MAPLEWOODS SUBDIVISION

MANSFIELD, CONNECTICUT

REVIEW DATE: JULY 21, 1988

**ENVIRONMENTAL REVIEW TEAM REPORT
ON**

PRELIMINARY CONCEPT PLAN

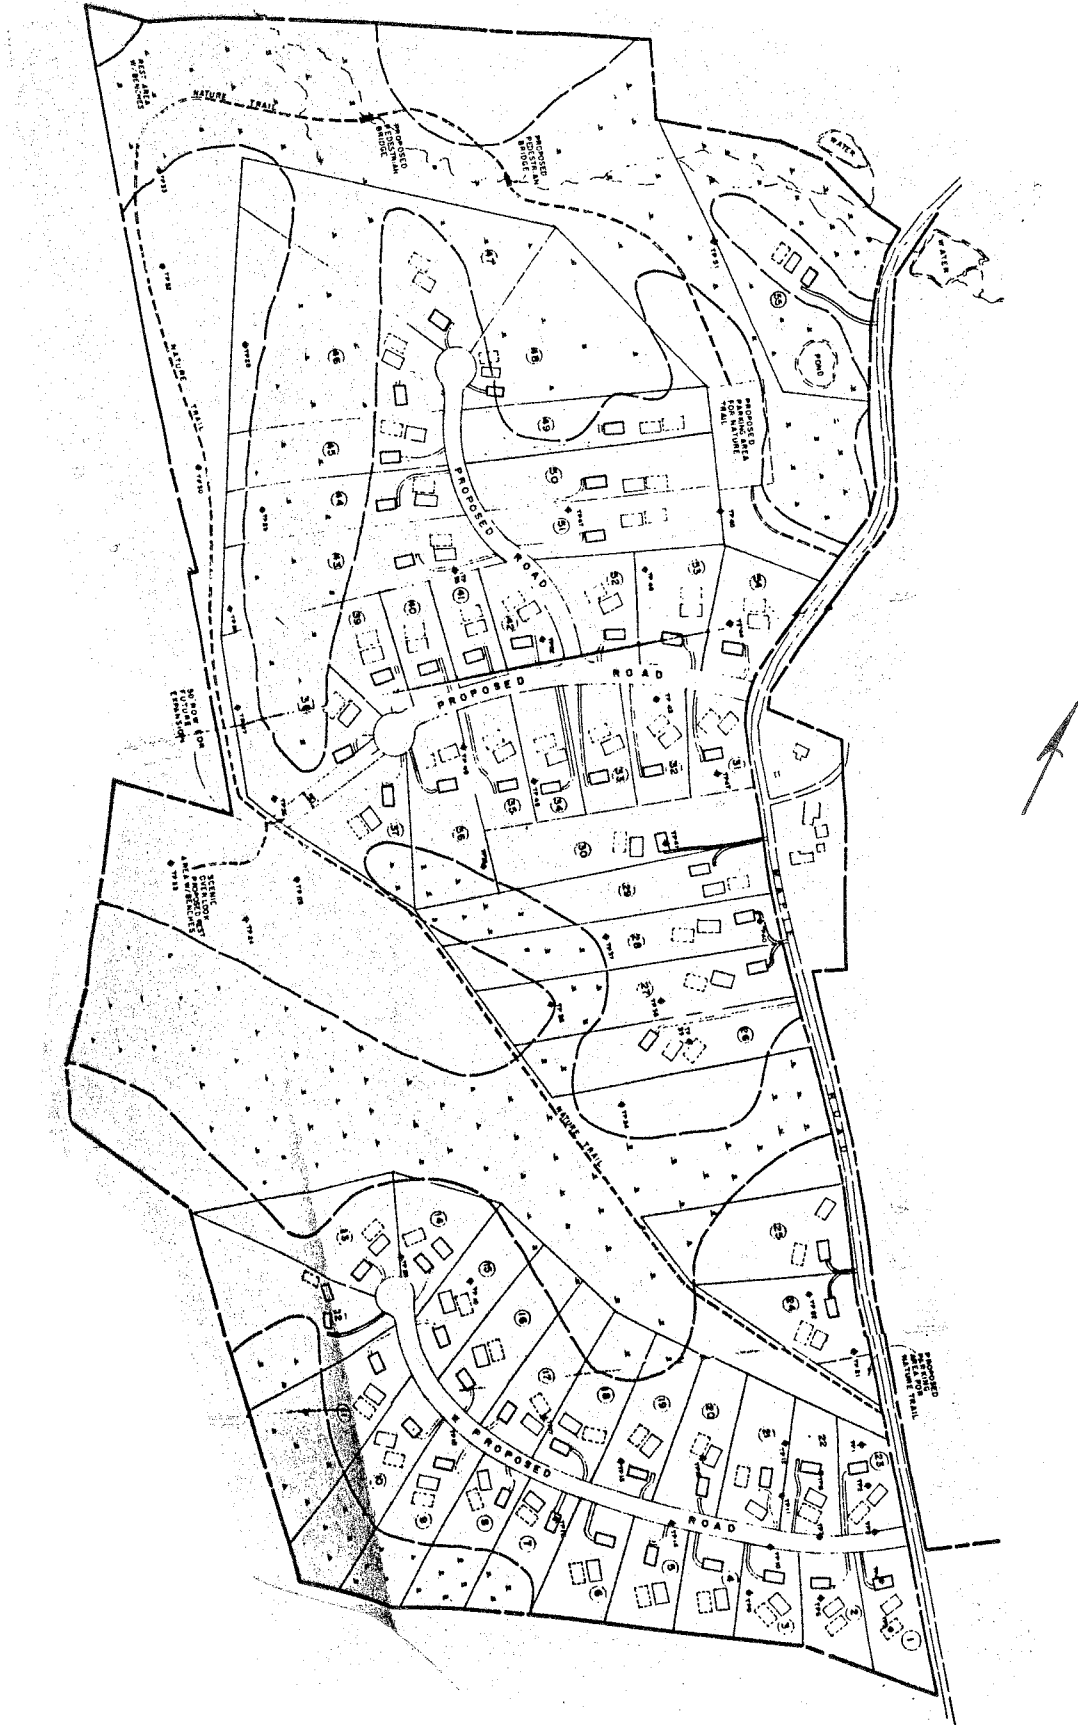
(3) All encroachment into or near the cedar swamp should be avoided. In addition, there is an overland hydraulic connection (intermittent drainage swale), between the cedar swamp and the adjacent wetland to the north. Though this swale probably only functions during high flow periods of the year or during storm events, it is a vital feature in maintain the existing hydrologic conditions. This area of critical concern corresponds to lots 7-13 on the previous preliminary concept plan.

Several measures can be taken to minimize the affect of development on wildlife. Since the development plans are in a preliminary stage, as much of the wetland areas as possible should be designated as open space. Owners on lots adjacent to or containing wetlands should be discouraged from any removal of vegetation within 100 feet of the wetland. These buffer strips will provide important corridors for a number of wildlife species. It would also be beneficial to wildlife if lot #55

was added to the designated open space because of its location between two critical wetland areas, a small pond and brook.
